## PCI-SIG ENGINEERING CHANGE NOTICE

<b>TITLE:</b>	Protocol Multiplexing
<b>DATE:</b>	June 17, 2010
<b>AFFECTED DOCUMENT:</b>	PCI Express 3.0 Revision 0.9
<b>SPONSOR:</b>	AMD, HP

#### **1. Summary of the Functional Changes**

**Figure 3-13: TLP Following Application of [TLP](#) Sequence Number and Reserved Bits**

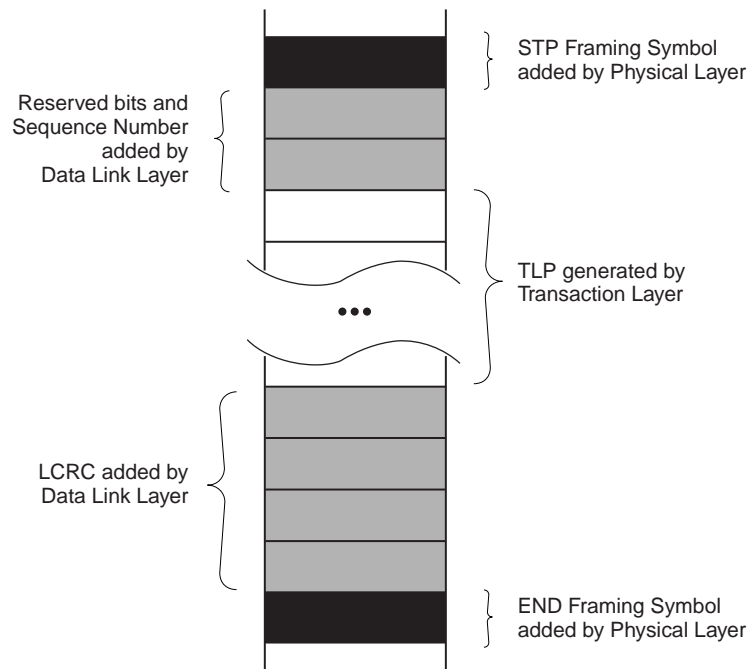
Modify Figure 3-13 in Section 3.5.2.1 as follows:

Editor: in Figure 3-13, change Symbol +0, Bits 7:4 so it has Bits 7:4 containing 0000b.

**Figure T-2: PMUX Link**

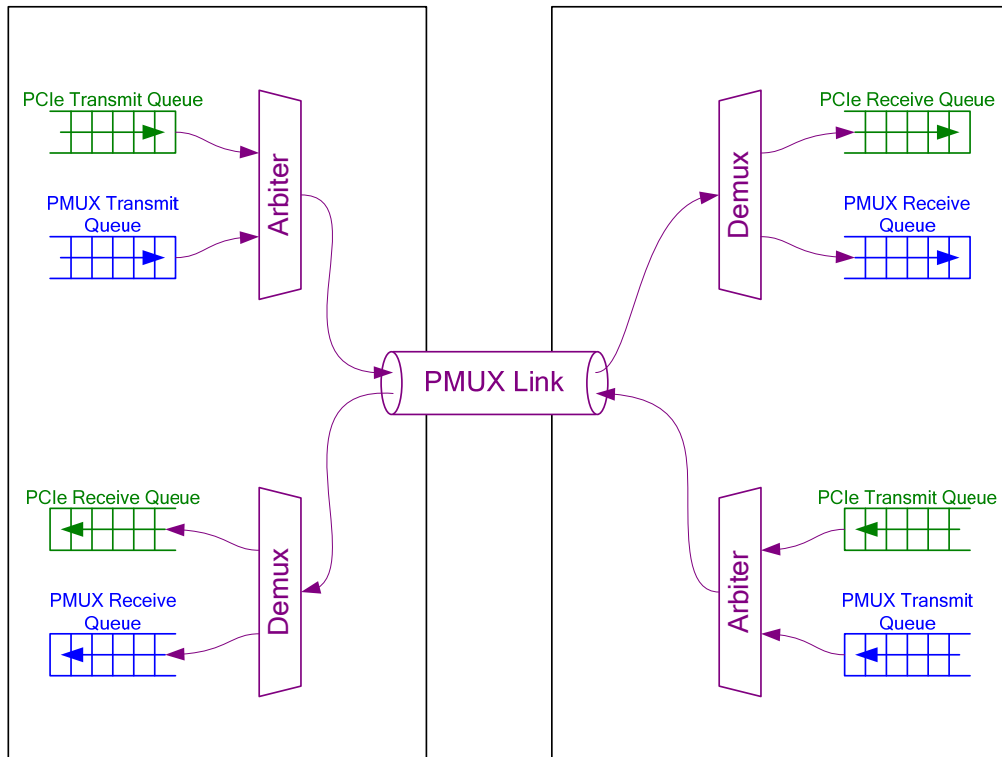
A PMUX Link is shown in Figure T-2. Arbitration and encapsulation occurs between the transmit queues and the Link. Demultiplexing and decapsulation occurs between the Link and the various receive queues. Packets are sent from transmit queues to the corresponding receive queues. Packets are identified as either PMUX Packets or TLPs.

**Figure T-3: PMUX Packet Flow Through the Layers**

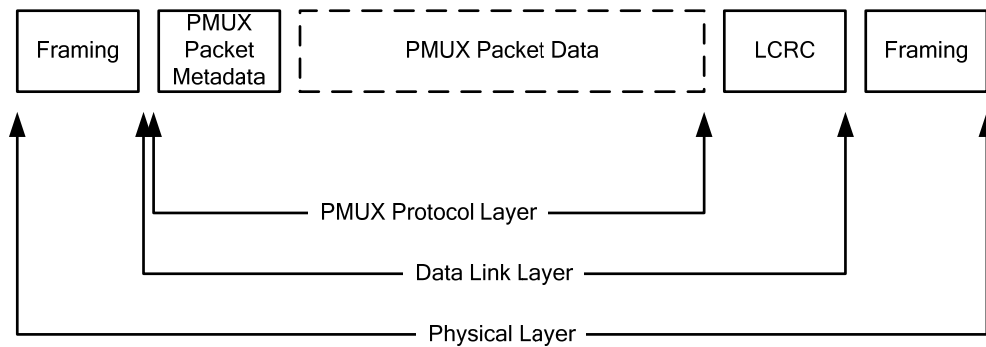
PMUX Packets are similar to PCIe TLPs. The PMUX Packet Flow Through is shown in Figure T-3. The PCIe Packet Flow Through is shown in Figure 1-5. Changes from PCIe Packet Flow Through are:

- ❑ PMUX Packets use a protocol specific PMUX Protocol Layer instead of the PCIe Transaction Layer.
- ❑ PMUX Packets use a simplified Data Link Layer. The packet integrity portion of the Data Link Layer is mostly unchanged (LCRC computation uses a different seed value). The reliability and flow control aspects of the Data Link Layer are removed (the TLP Sequence Number field is repurposed as PMUX Packet Metadata).
- ❑ The Physical Layer is slightly modified to provide a mechanism to identify PMUX Packets.

**Figure T-4: PMUX Packet**

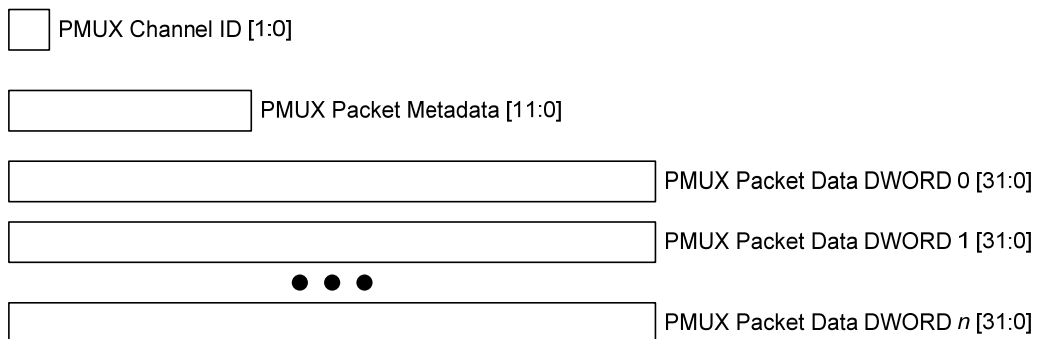
A PMUX Packet contains the information shown in Figure T-4

PMUX Channel ID is a 2 bit field that identifies which protocol is associated with a PMUX Packet. PMUX Channel ID values are between 0 and 3 (inclusive).

PMUX Packet Metadata is a 12 bit field that provides information about the PMUX Packet. Definition of this field is protocol specific and is outside the scope of this specification.

A PMUX Packet consists of between 0 and 125 DWORDs of PMUX Packet Data. Layout and usage of these DWORDs is protocol specific and is outside the scope of this specification. A PMUX Packet need not have any PMUX Packet Data and may consist only of PMUX Channel ID and PMUX Packet Metadata.

**Figure T-5: TLP and PMUX Packet Framing (8b10b encoding)**

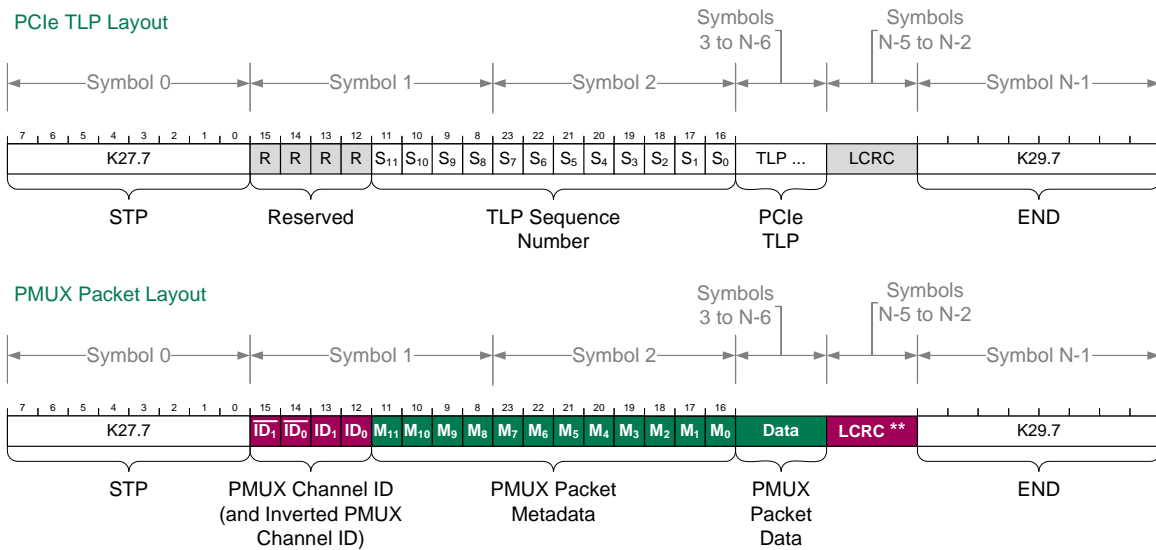
Figure T-5 and Table T-3 show the layout of PMUX Packets when using 8b10b encoding. For reference, the 8b10b encoding of a TLP is also shown (see Section 4.2.1.2 for the official definition). In Table T-3, items shown in *italics* are identical in PMUX Packets and TLPs.

\*\* LCRC for PMUX Packets uses a different starting seed than that used for TLPs . This avoids aliasing problems and potential errors if software misconfigures a link so that PMUX Packets are seen by existing silicon.

Figure T-6: TLP and PMUX Packet Framing (128b/130b encoding)

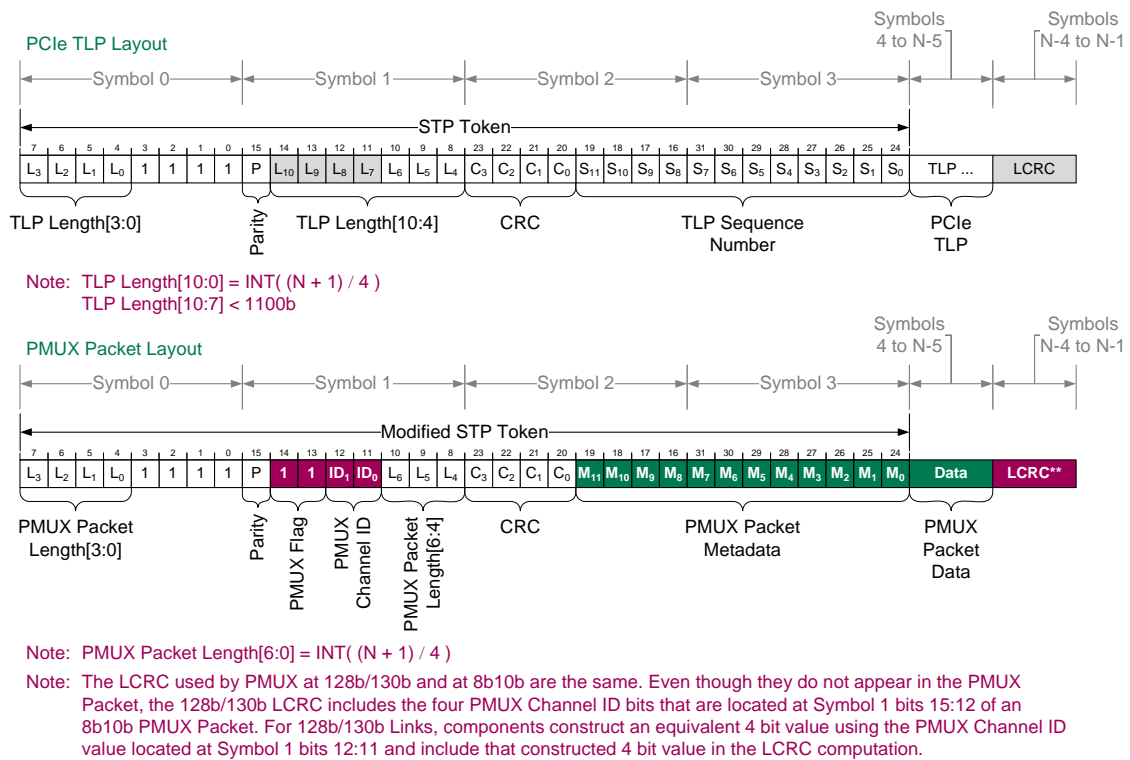
Figure T-6 and Table T-4 show the layout of PMUX Packets when using 128b/130b encoding. For reference, the 128b/130b encoding of a TLP is also shown (see Section 4.2.2.2 for the official definition). In Table T-4, items shown in *italics* are identical in PMUX Packets and TLPs.

Table T-5 describes the encodings of Symbol 1 bits [6:3] in more detail. If these bits contain a value less than 1001b, the packet is a TLP and is processed as described in section 4.2.2.<sup>3</sup> If these bits contain 1001b, 1010b or 1011b, the encoding is reserved for future standardization and is processed as described in Section 4.2.2.3.3. If these bits contain a value greater than or equal to 1100b, the packet is a PMUX Packet is defined as specified in this appendix.<sup>4</sup>

**Figure T-7: PMUX Extended Capability**

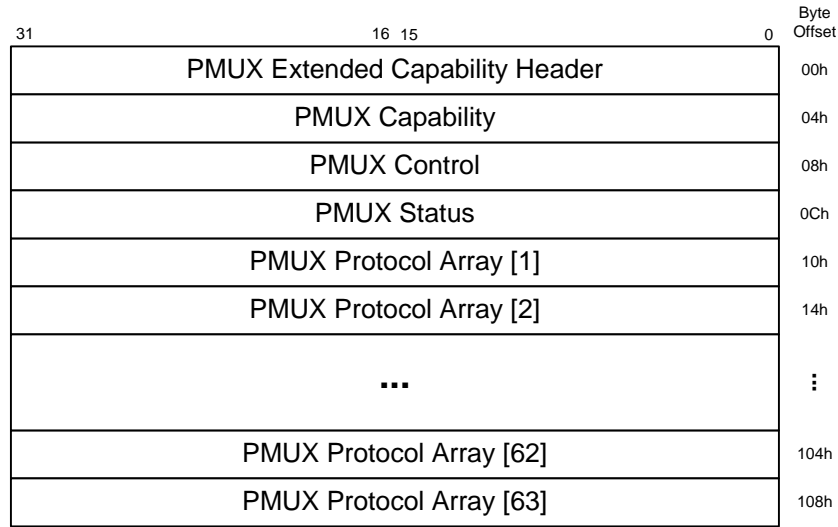
Figure T-7 shows the PMUX Extended Capability structure. The presence of this capability indicates that the Port supports the optional Protocol Multiplexing mechanism. This capability is optional and may be present in any Downstream Port and in Function 0 of any Upstream Port. It must not be present in non-zero Functions of Upstream Ports or in RCRBs.

The length of the PMUX Extended Capability is determined by the PMUX Protocol Array Size field (see Section T.5.2).

This capability contains a list of the protocols supported by the Link (the PMUX Protocol Array). It also contains the mechanism software uses to enable and configure PMUX Channels. This capability must be present in both the Upstream and Downstream Ports of a Link in order for Protocol Multiplexing to be successfully enabled.

**Figure T-9: PMUX Capability Register**

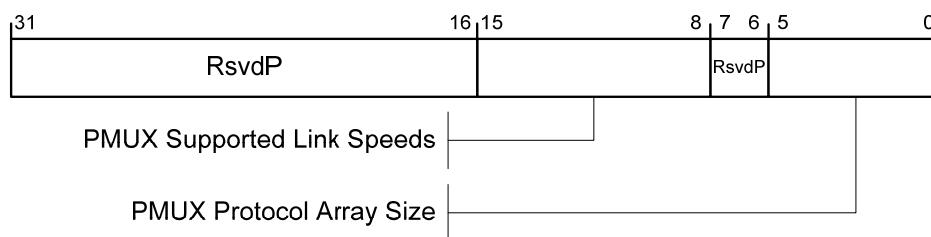
Figure T-9 details the allocation of fields in the PMUX Capability register. Table T-7 provides the respective bit definitions.

**Figure T-11: PMUX Status Register**

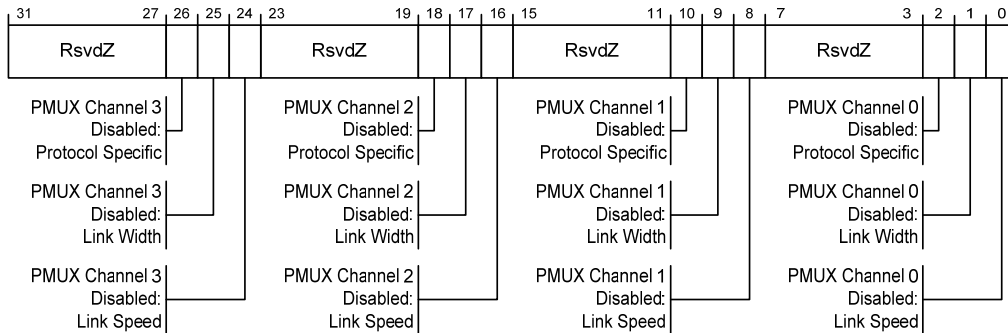
Figure T-11 details the allocation of fields in the PMUX Status register. Table T-9 provides the respective bit definitions.

Each channel has a set of Disabled bits. When Channel  $n$  Assignment field is non-zero, the Channel  $n$  Disabled bits reflect the error status of the channel. The following Disabled bits are defined:

- PMUX Channel  $n$  Disabled: Link Speed
- PMUX Channel  $n$  Disabled: Link Width
- PMUX Channel  $n$  Disabled: Protocol Specific

When there are multiple reasons for disabling a channel, an implementation may choose which reason(s) to report. For example, if a protocol needs bandwidth equivalent to  $x1$  8.0 GT/s, when there is inadequate bandwidth (e.g. the Link is operating at  $x1$  5.0 GT/s,  $x1$  2.5 GT/s, or  $x2$  2.5 GT/s) it could disable the PMUX Channel by indicating any or all of Disabled: Link Width, Disabled: Link Speed or Disabled: Protocol Specific.
